ADDENDUM NO. 01

Project: Shelby County Sheriff's Department
Equipment Storage Building
RFP 14-004-60

Date: May 16, 2014

SD01

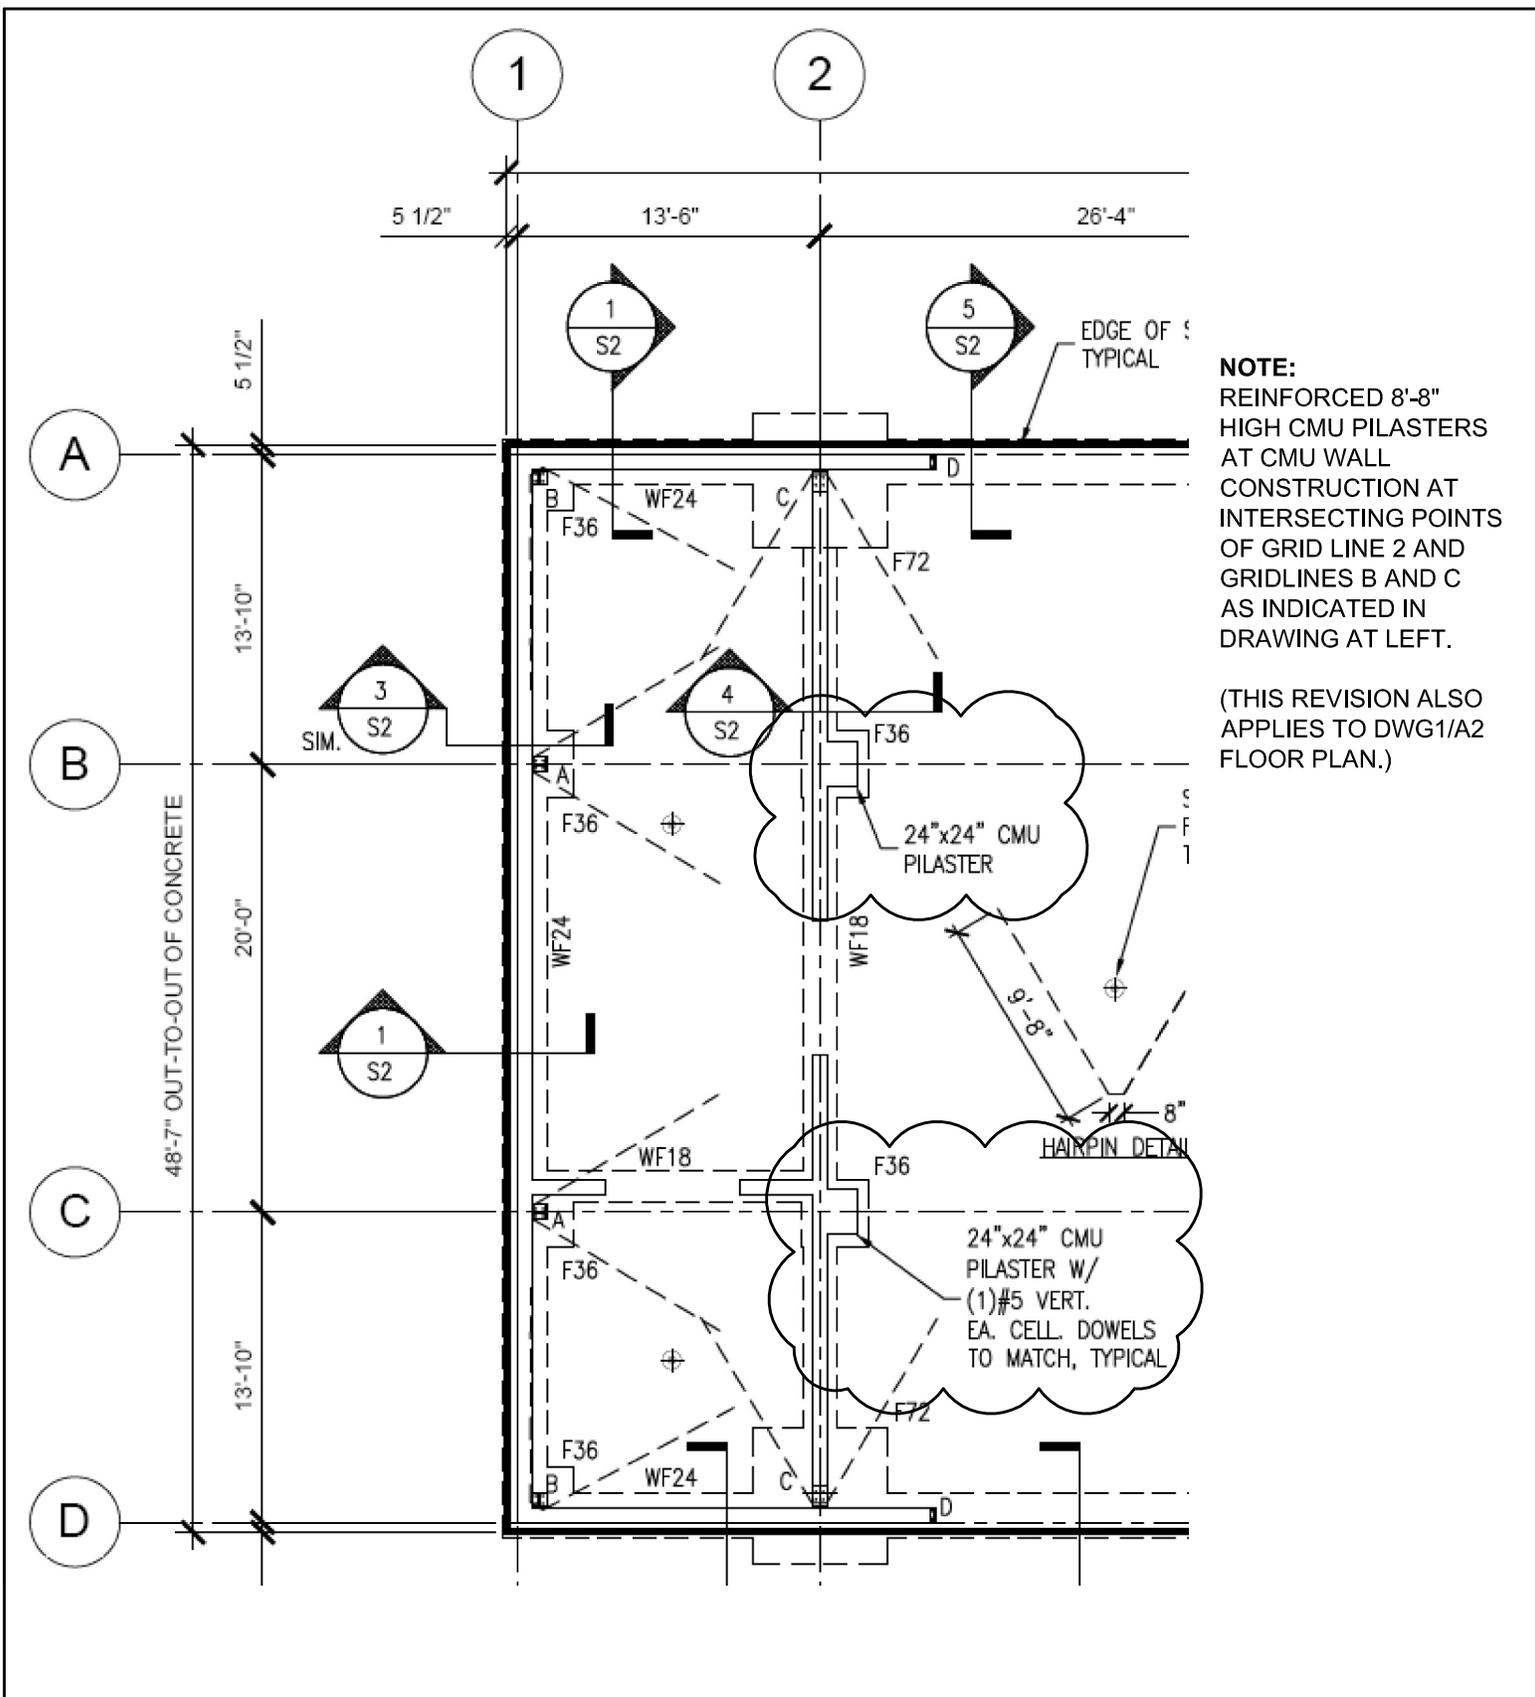
Item 9 Sheet A1 (Drawing 2, Site Plan)

Additional Information at Accessible Parking and Access Aisle

Refer to [attached Supplemental Drawings SD01](#) for additional information at the replacement Accessible Parking Spaces and Access Aisle.

NOTE: CONTRACTOR SHALL RESTRIPE ALL AREAS OF EXISTING STRIPED PAVEMENT THAT WERE DISTURBED DURING THE SCOPE OF WORK OF THIS PROJECT.
